Product Change Notification / SYST-08OAYW733

ERRATA - PIC24FJ256GB110 Family Silicon/Data Sheet Errata Document Revision

PIC24FJ256GB110 Family Silicon Errata and Data Sheet Clarification

FIGURE 2-3 FREQUENCY vs. ESR PERFORMANCE FOR SUGGESTED VCAP

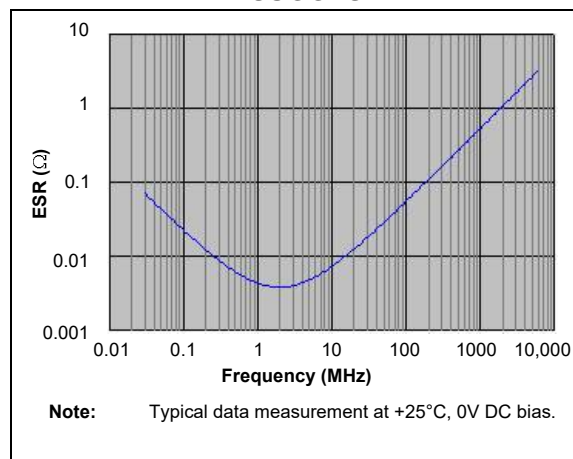
Designers may use [Figure 2-3](#) to evaluate ESR equivalence of candidate devices.

FIGURE 2-4 DC BIAS VOLTAGE vs. CAPACITANCE CHARACTERISTICS

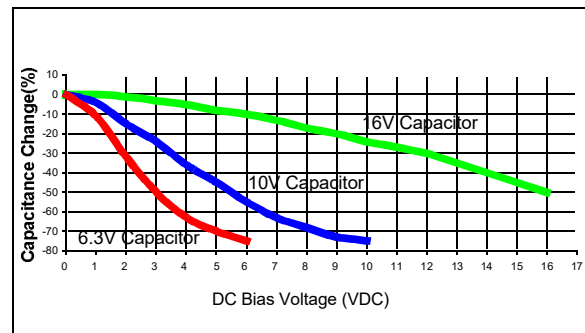
A typical DC bias voltage vs. capacitance graph for 16V, 10V and 6.3V rated capacitors is shown in Figure 2-4.

When selecting a ceramic capacitor to be used with the internal voltage regulator, it is suggested to select a high-voltage rating, so that the operating voltage is a small percentage of the maximum rated capacitor voltage. For example, choose a ceramic capacitor rated at 16V for the 2.5V core voltage. Suggested capacitors are shown in Table 2-1.

FIGURE 29-1: PIC24FJ256GB110 FAMILY VOLTAGE-FREQUENCY GRAPH (INDUSTRIAL)

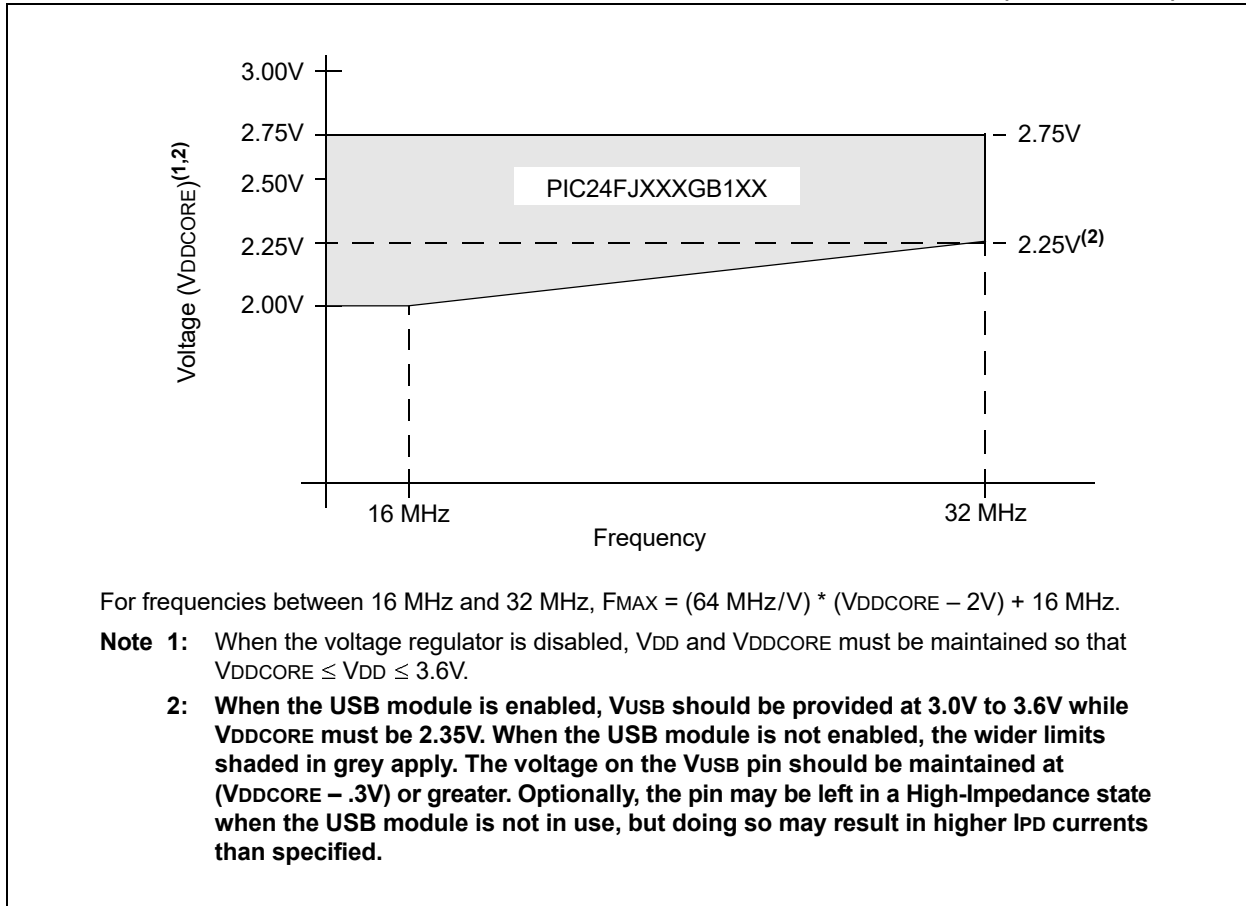
Figure 29-1 (“PIC24FJ256GB110 Family Voltage-Frequency Graph”) is amended by adding an additional footnote. The updated figure is shown below (changes in **bold**; bold in original removed for clarity).
